Amended Technical Specification Pages

Attachment C to BECo Letter 93-072

Marked-Up Pages

Attachment D to BECo Letter 93-072

PNPS TABLE 3.2.A
INSTRUMENTATION THAT INITIATES PRIMARY CONTAINMENT ISOLATION

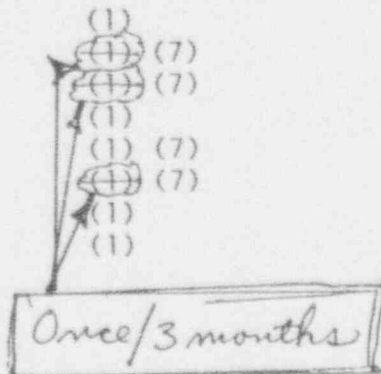
Operable Instrument Channels Per Trip System (1)		Instrument	Trip Level Setting	Action (2)
Minimum	Available			
2(7)	2	Reactor Low Water Level	≥ 11.7 9" indicated level (3)	A and D
1	1	Reactor High Pressure	≤ 110 psig	D
2	2	Reactor Low-Low Water Level	at or above 49 ^{46.3} in. indicated level (4)	A
2	2	Reactor High Water Level	≤ 45.3 48" indicated level (5)	B
2(7)	2	High Drywell Pressure	≤ 2.22 2.5 psig	A
2	2	High Radiation Main Steam Line Tunnel (9)	≤ 7 times normal rated full power background	B
2	2	Low Pressure Main Steam Line	≥ 810 880 psig (8)	B
2(6)	2	High Flow Main Steam Line	$\leq 140\%$ of rated steam flow	B
2	2	Main Steam Line Tunnel Exhaust Duct High Temperature	$\leq 170^{\circ}\text{F}$	B
2	2	Turbine Basement Exhaust Duct High Temperature	$\leq 150^{\circ}\text{F}$	B
1	1	Reactor Cleanup System High Flow	$\leq 300\%$ of rated flow	C
2	2	Reactor Cleanup System High Temperature	$\leq 150^{\circ}\text{F}$	C

3. Instrument set point corresponds to ~~128.26~~^{130.96} inches above top of active fuel.
4. Instrument set point corresponds to ~~77.26~~^{79.96} inches above top of active fuel.
